INTERSTATE ROUTE H-3

July 1971 Env. Center Review of H-3

Jan. 1972 Env. Center Review of "Pre-Final"
DOT Impact Statement

Statement for Department of Transportation Hearing
31 August 1973

Fig. 2 — Sediment delivery ratio versus size of drainage area.

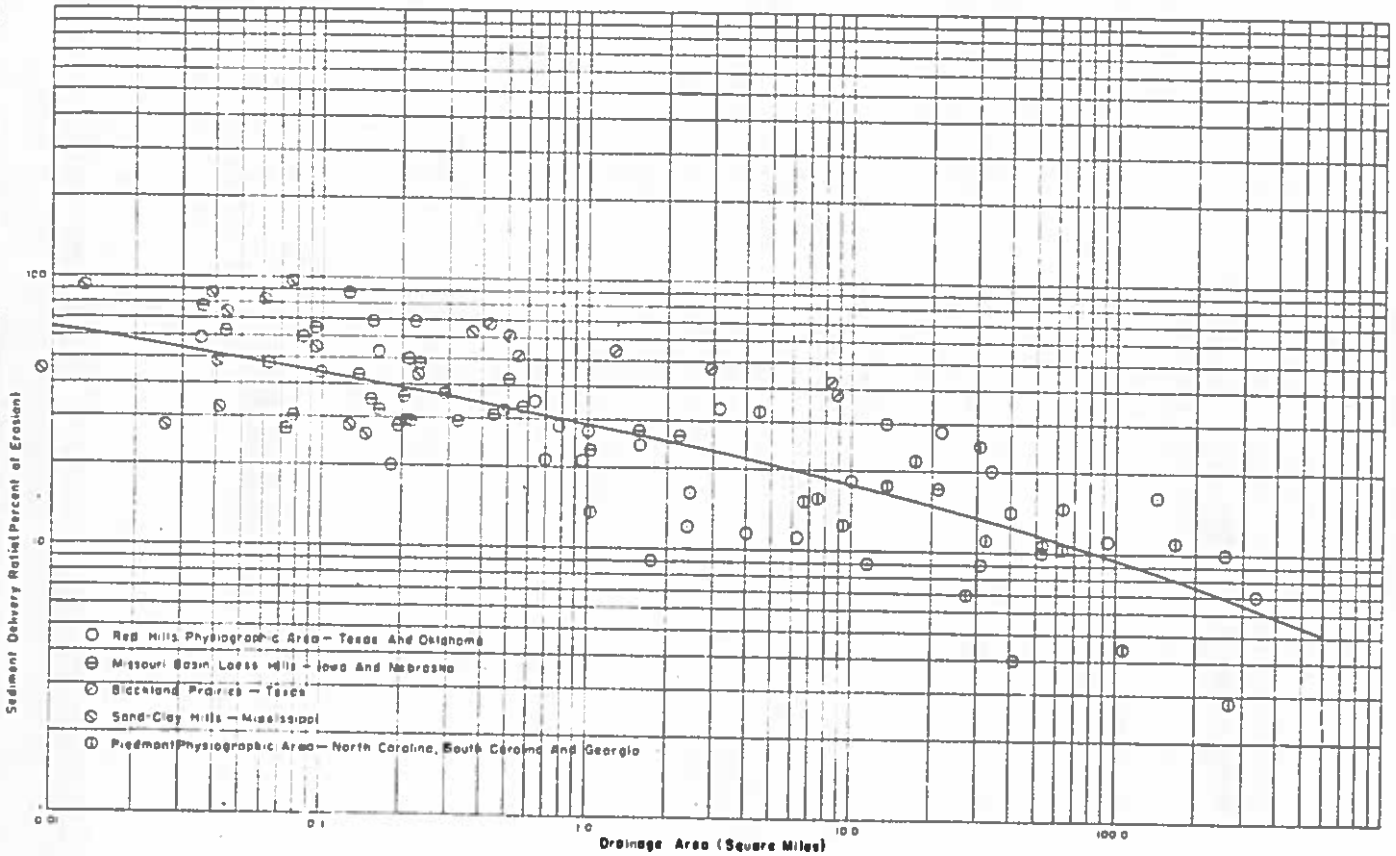
The gross erosion must be reduced by a delivery ratio to get net sediment reaching the Bay. The delivery ratio curve generally used is shown on the next page. From this curve, a 22% delivery ratio is selected for a 4.38 square mile watershed (Kamooalii). This would give "net" sediment rates of about 1155 tons/acre/year for soil exposed year-round. If total soil acreage exposed in highway construction is 17 acres at any one time, then the total added sediment yield of this exposure is 17 x 1155 = about 19,600 tons/year. This compares with the 750 additional tons/year estimated by Ocean Engineering Consultants.
